**PLEASANT PRAIRIE PLAN COMMISSION MEETING
VILLAGE HALL AUDITORIUM
9915 39th AVENUE
PLEASANT PRAIRIE, WISCONSIN
6:00 P.M.
JULY 27, 2015**

- B. Consider the request of Lance Skala, agent for Centerpoint Wispark Land Company, LLC owners, for approval of a **Site and Operation Plan** for a 204,387 square foot speculative warehouse and distribution building on the property located at the southwest corner of STH 165 and CTH H in Lake View Corporate Park.

Consider the request of Lance Skala, agent for Centerpoint Wispark Land Company, LLC owners, for approval of a **Site and Operation Plan** for a 204,387 square foot speculative warehouse and distribution building on the property located at the southwest corner of STH 165 and CTH H in LakeView Corporate Park.

SHEET NUMBER:
C-2.0

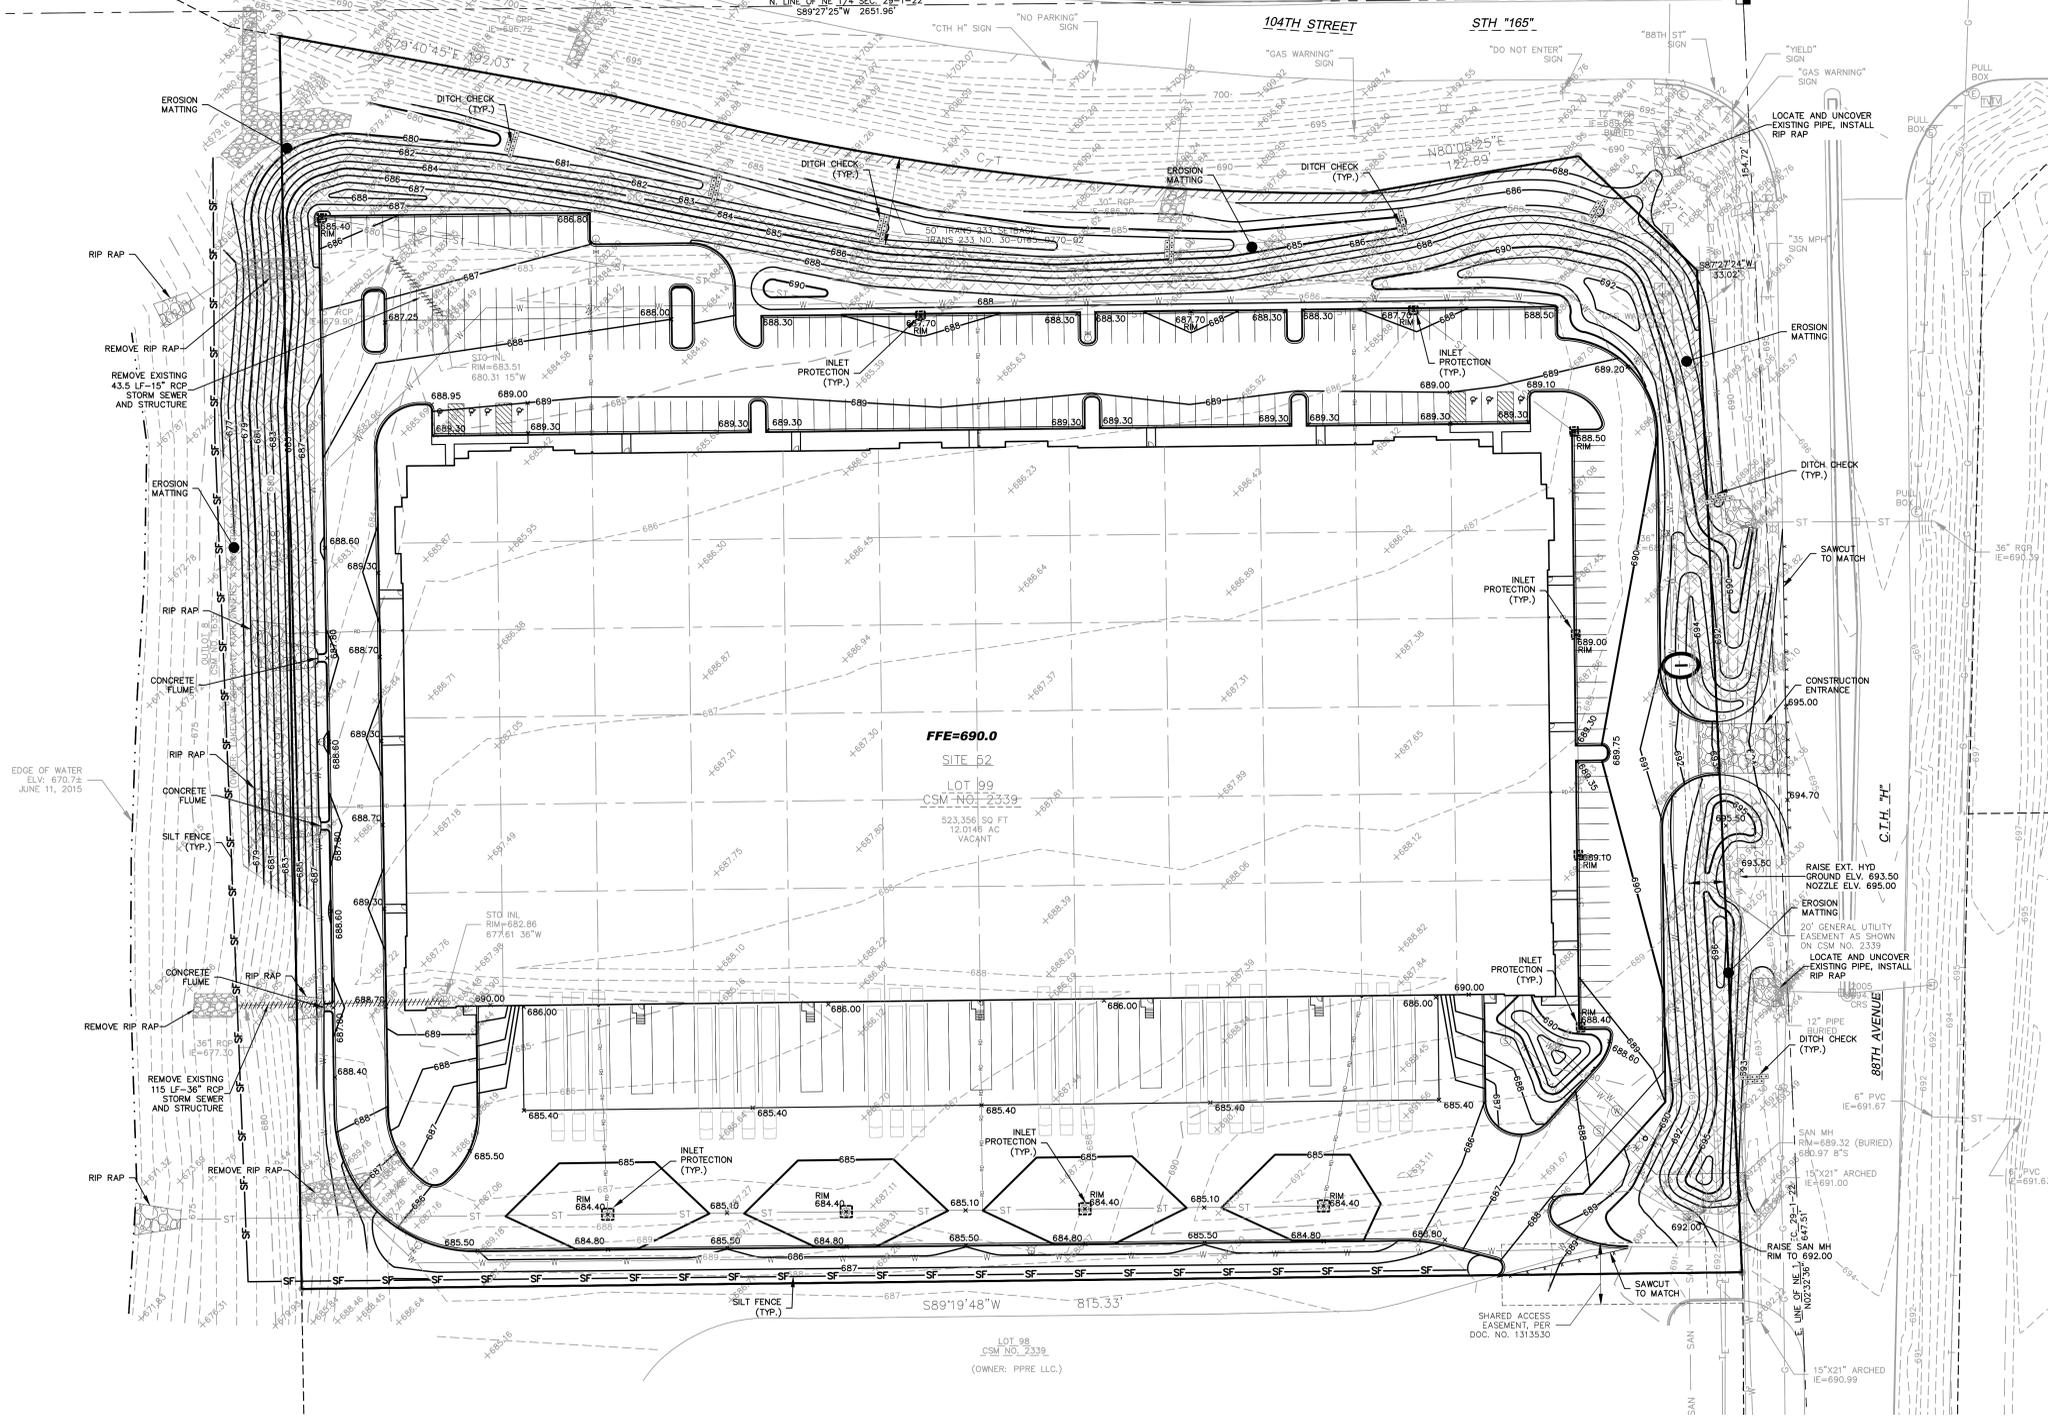
- (5) The building sign is located within the general utility easement. Contact Tracy Zweibel at We Energies, 262-694-9304, for approval.
- g. On the Site Grading & Erosion Control Plan (Sheet C-2.0)

SHEET NUMBER:
C-4.0

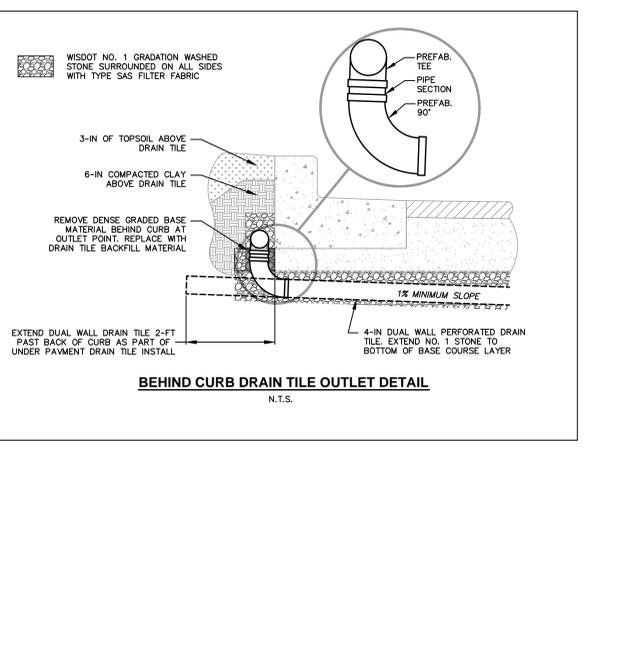
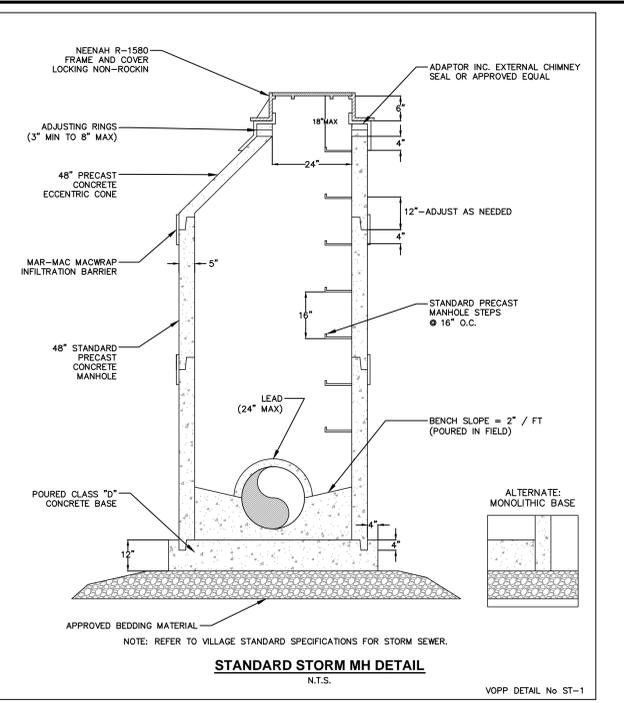
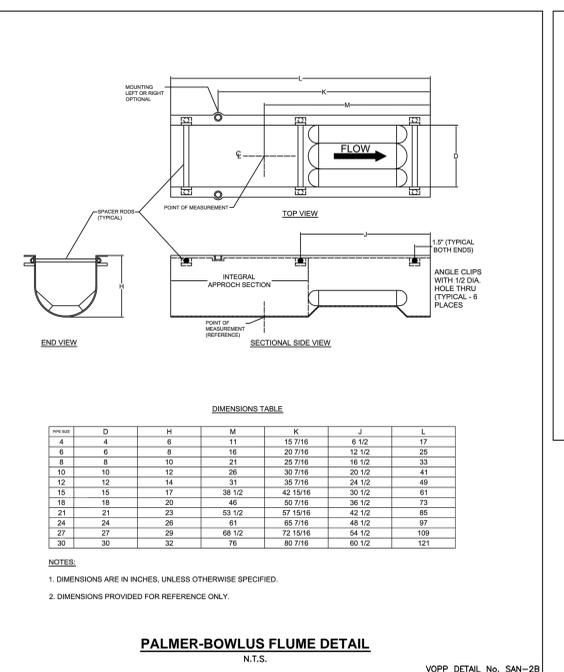
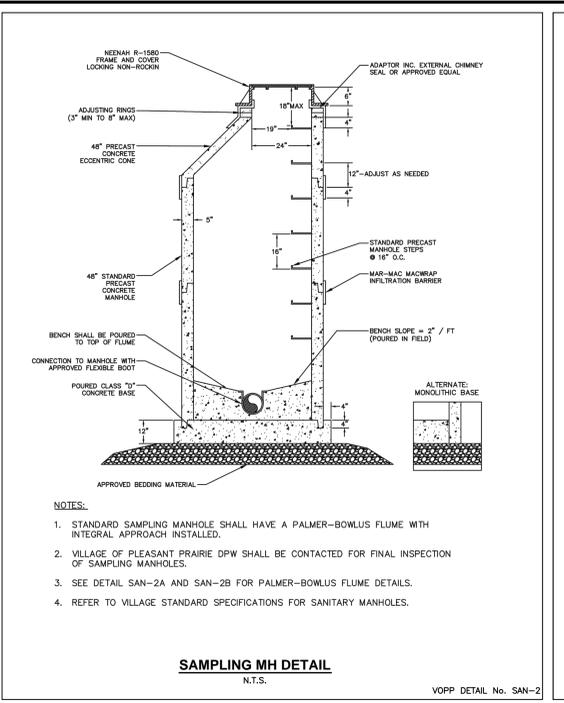
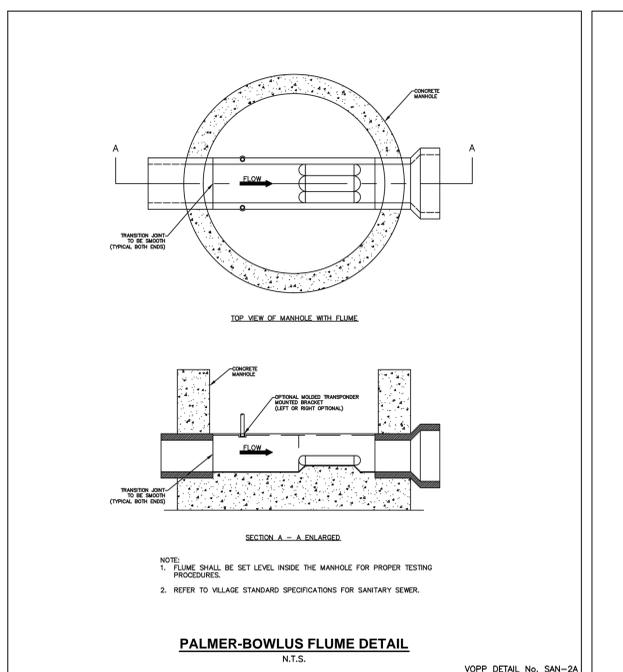
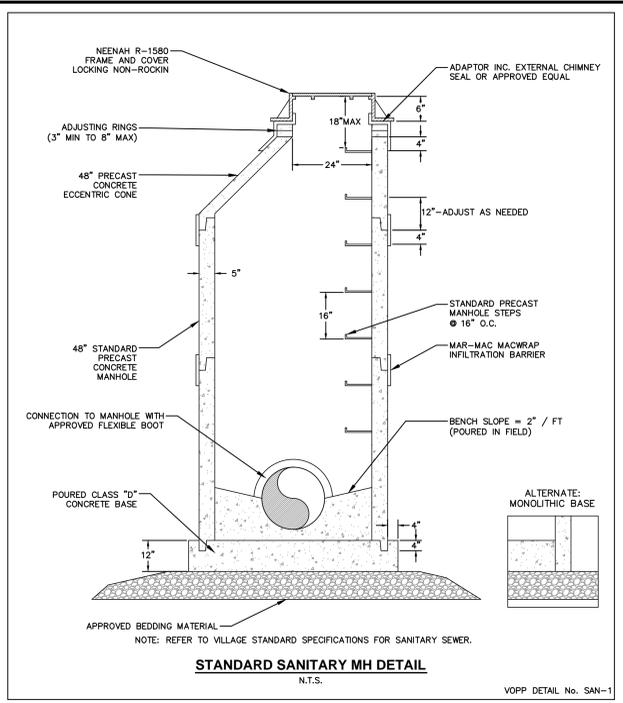
- i. On the Site Notes and Details Plan (Sheet C-4.0, C-4.1)
 - i. A detail of the ADA parking sign shall be included.
 - ii. Details of the right-in/right-out only signage for the northernmost 88th Avenue entrance shall be included.

- vi. Where is the integral concrete curb and walk to be installed?
 - vii. Compare manhole and catch basin details to utility notes on Sheet C-3.0. revise notes or details as necessary to match.

- viii. Add fire department pumper pad detail.
- j. On Sheet L1.0, show the right-of-way.
- k. On Sheet A1.0 & A3.1:
 - i. Sheets A1.0 & A3.1 indicate that the building is 204,387 square feet, while the Site and Operational Plan application notes that the building is 203,105 square feet. Clarify.
